IREDELL COUNTY HEALTH DEPARTMENT

IMPROVEMENT PERMIT / AUTHORIZATION TO CONSTRUCT / OPERATION PERMIT / EXISTING SYSTEM

RE: Lot 196 CL&T Fast Tract Septic Redraw Request

CL&T Lot 196 Fast Track Septic System Information

INITIAL SITE SKETCH

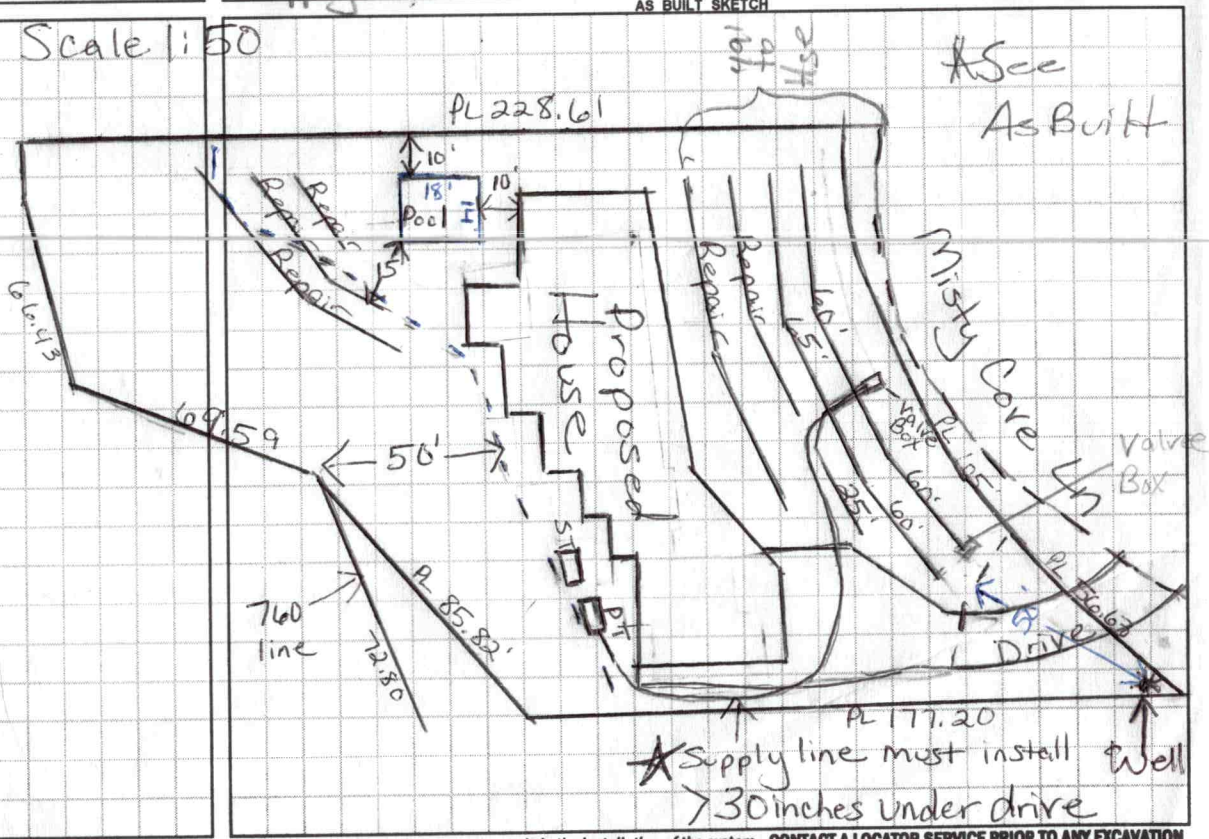
Comments / Conditions: * Supply line must be installed at least 30" under driveway & keep at least 50ft from well. If less than 50ft from well then must use Ductile iron for Supply line

* Septic tank & Pumptank have already been installed. Inspected 9-2-14 by ALP
5/32" hole drilled
Supply line 30" under drive 11/2ft off PL

6/24/15 Set 2ft pressure, checked
Elect & alarm

* Supply line must install >30 inches under drive

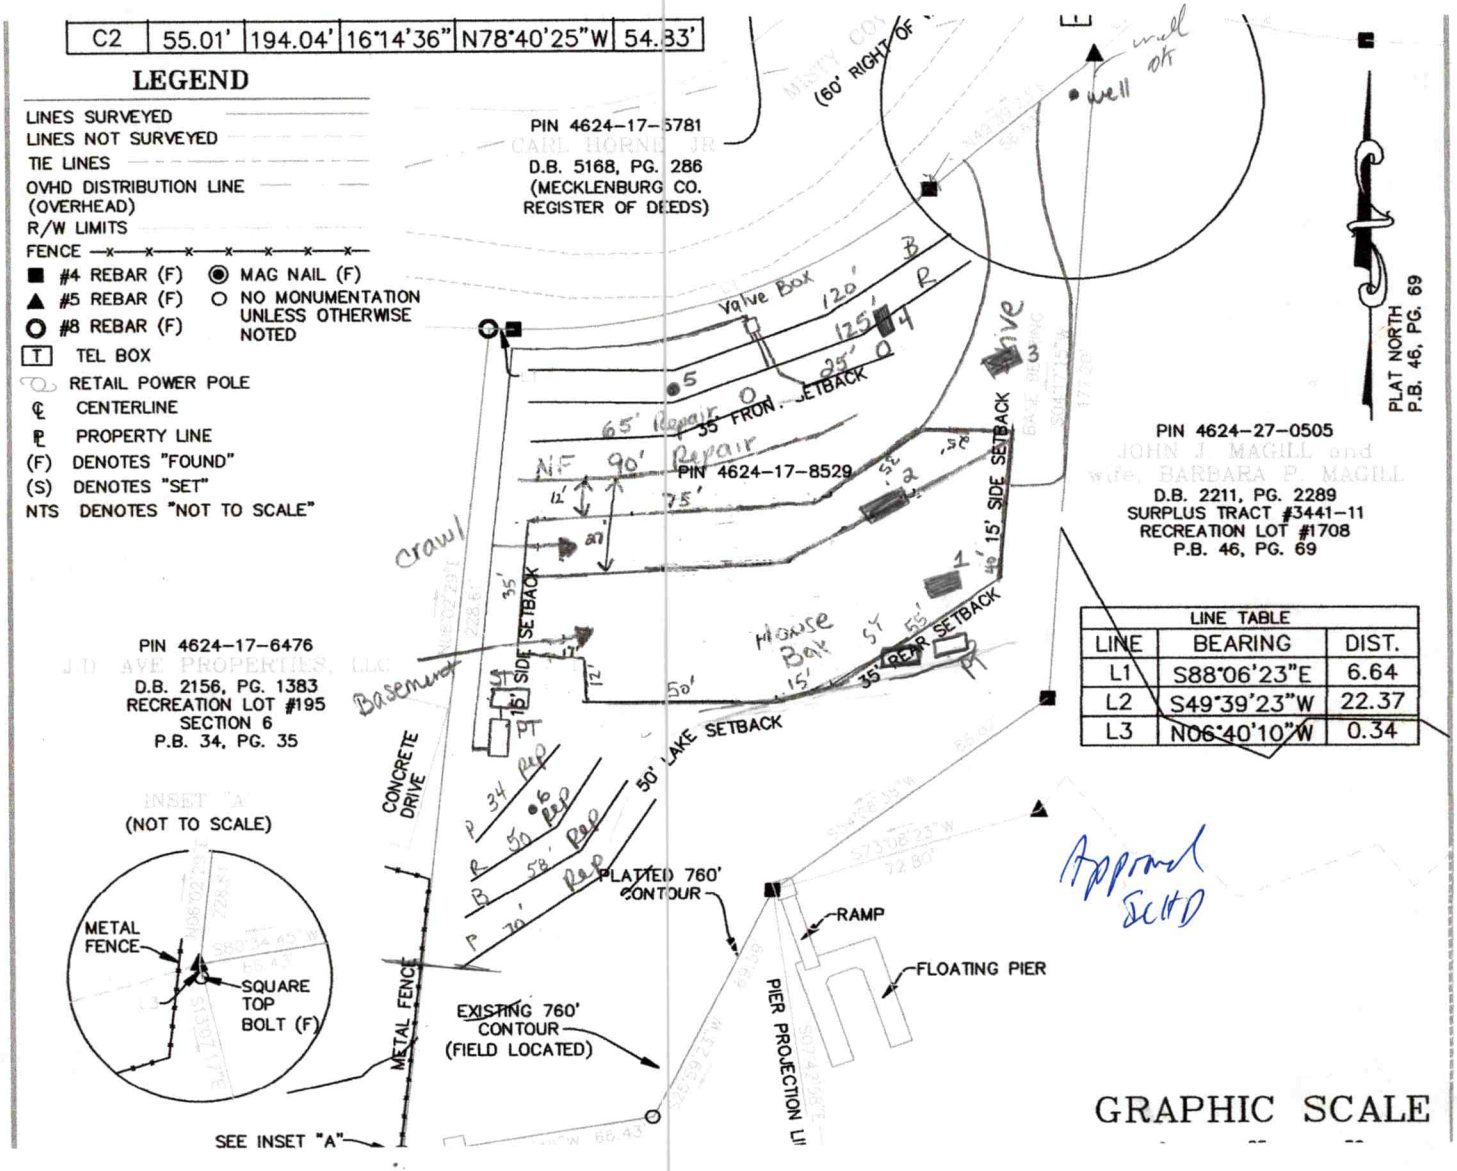
All septic lines located by a licensed surveyor except line marked "NF"

partial Repair < 50' from 760' contour
(> 30' from 760' contour)
Repair will require TSII pretreatment if portion inside buffer used
